**Origination Form**  
 Proposed Revisions to a Standard Plans Index

<b>Originator:</b>	Gibbs, Shae	<b>Index Number:</b>	711-003
<b>Date:</b>	5/5/2025	<b>Sheet Number(s):</b>	2,5,6,7
<b>E-mail:</b>	shae.gibbs@dot.state.fl.us	<b>Index Title:</b>	Interchange Markings

**Summary of the changes:**

1. Extend this 8" white Pavement Marker one-fourth the length of the acceleration lane from the gore markings.
2. See Index 711-001 for pavement message dimensions and details.
3. Merge Pavement Message and Arrow only used for Two-Lane Entrances.

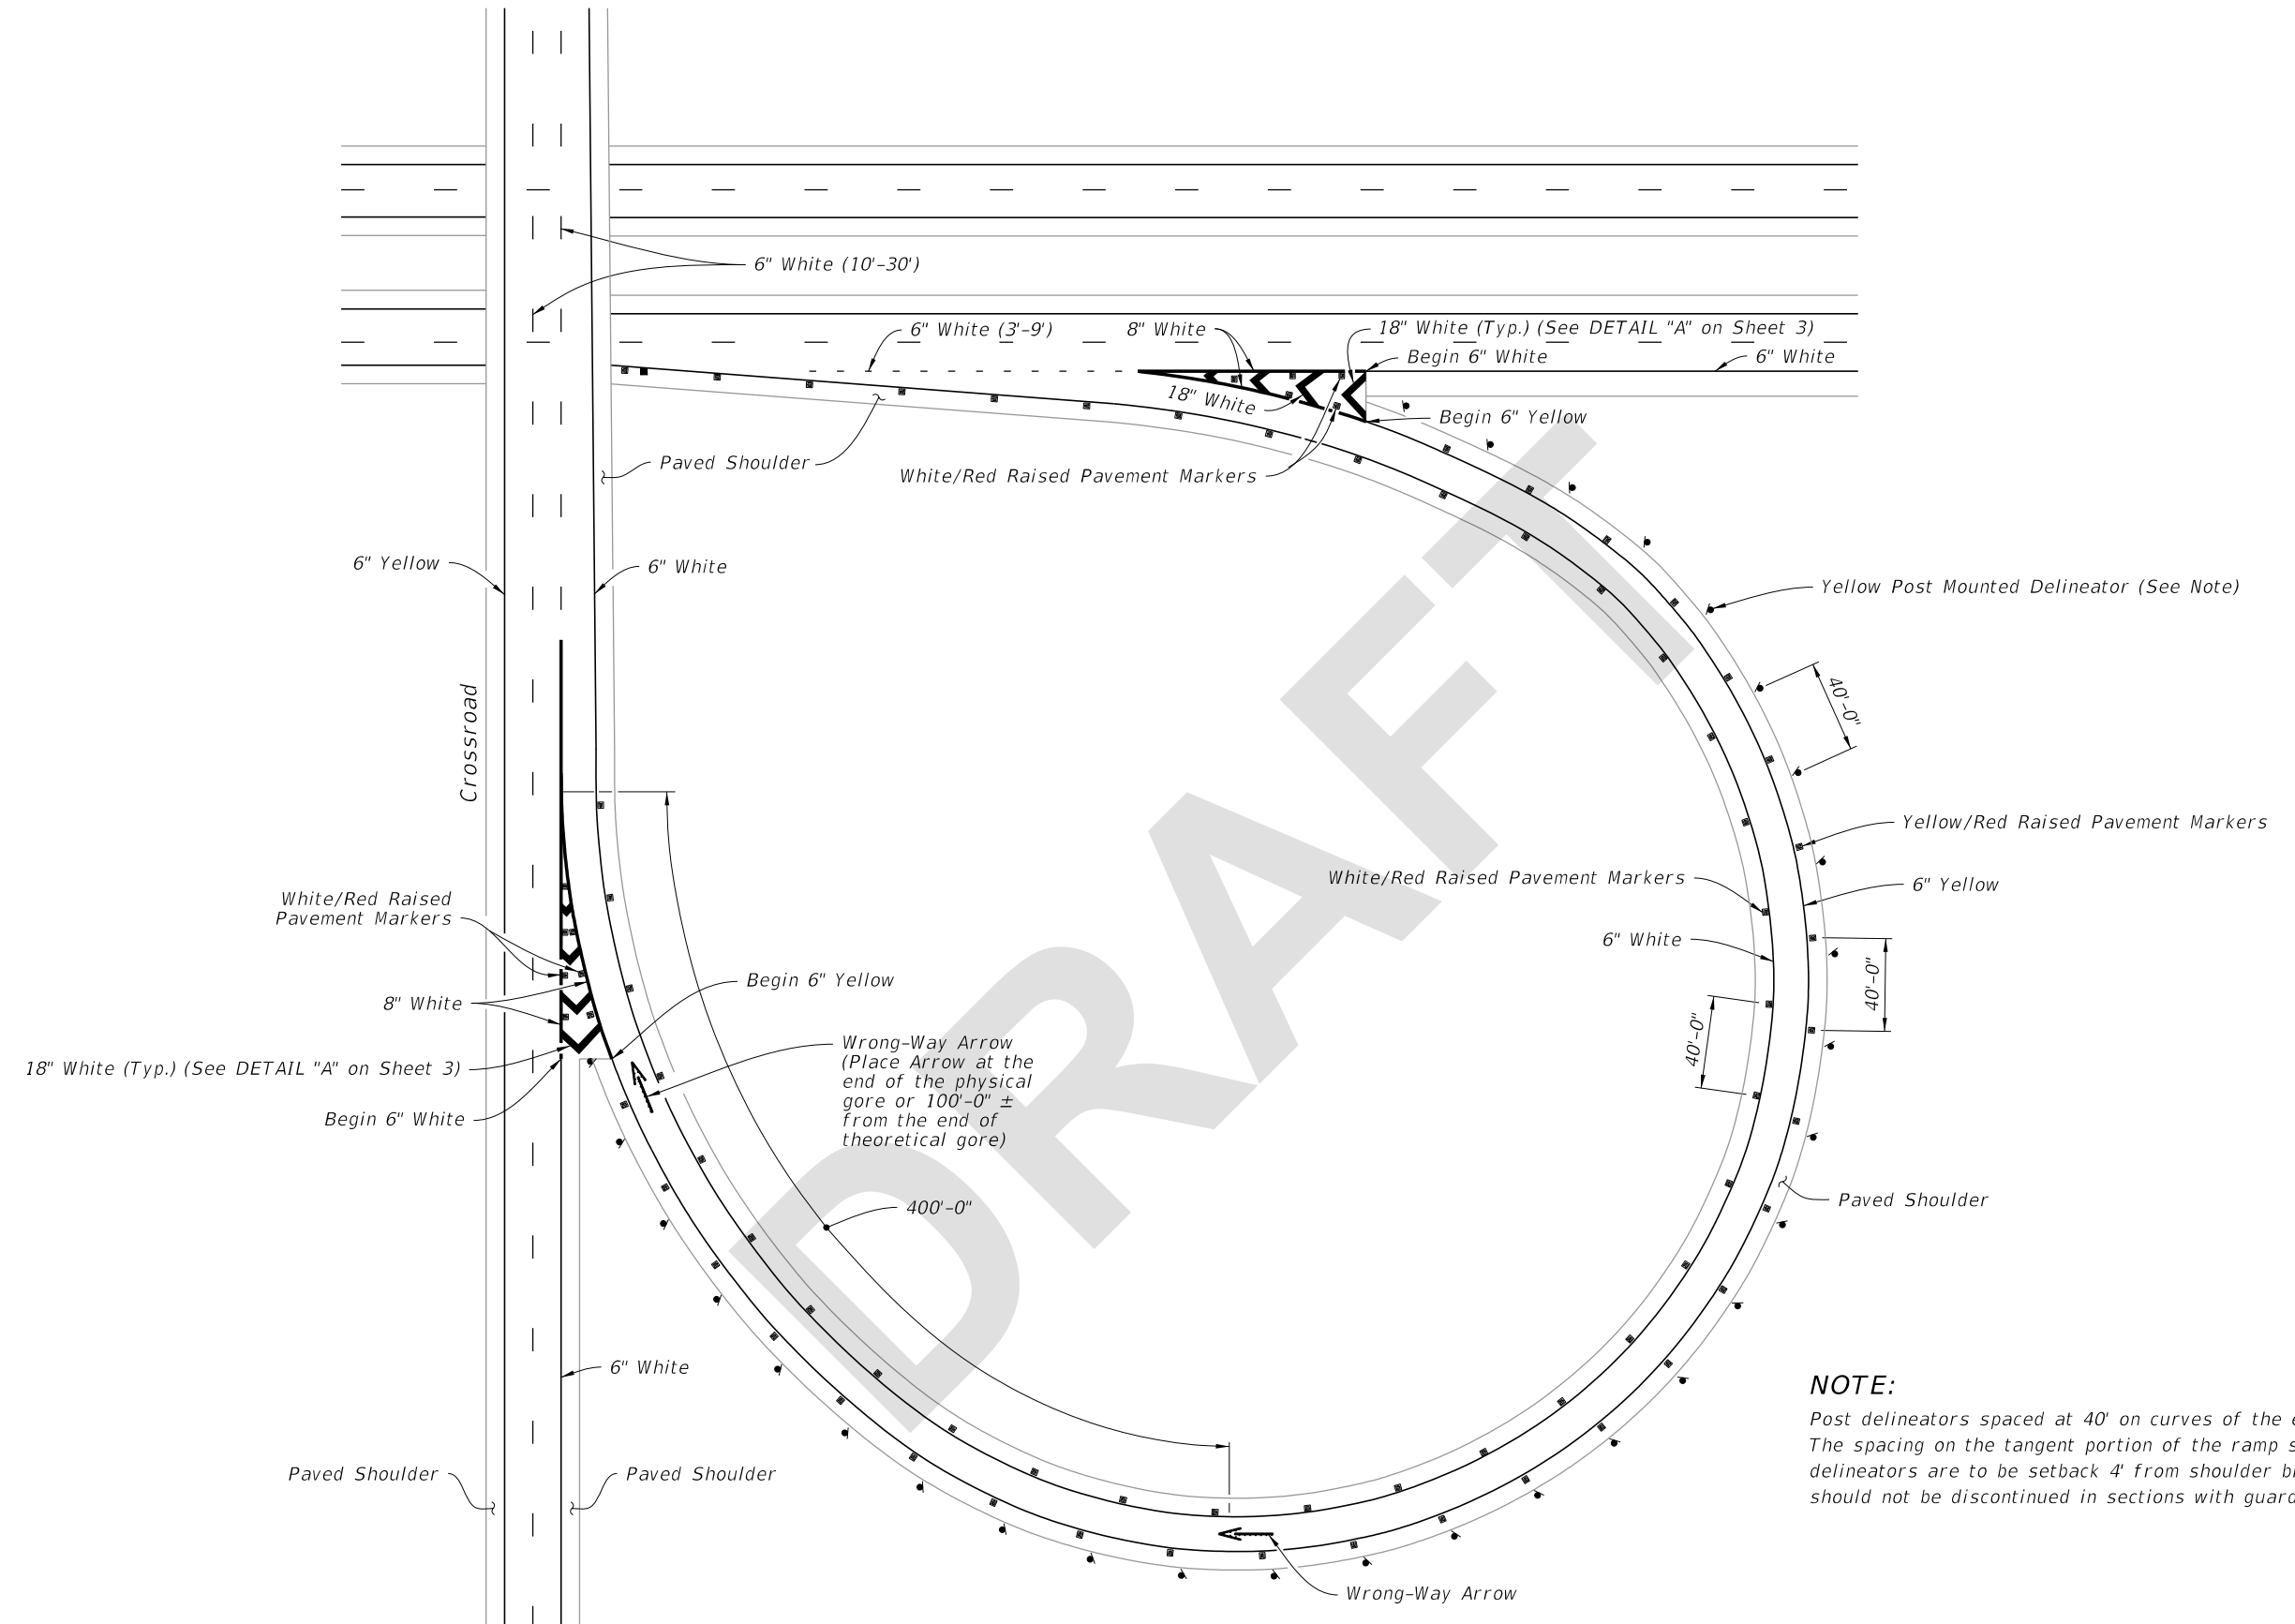
Sheet 2: Added SINGLE-LANE PARALLEL-TYPE ENTRANCE WITHOUT ADDED LANE detail.  
 Sheet 5: Updated wrong-way arrows to match 706-001.  
 Sheet 6: Updated wrong-way arrows to match 706-001.  
 Sheet 7: Updated wrong-way arrows to match 706-001, removed edge line markings from crosswalk areas.

Sheet 2: Due to ongoing confusion on what striping to use in Parallel-Type Entrances, a detail was added for SINGLE-LANE PARALLEL-TYPE ENTRANCE WITHOUT ADDED LANE for clarification

ADDED: SINGLE-LANE PARALLEL-TYPE ENTRANCE WITHOUT ADDED LANE detail
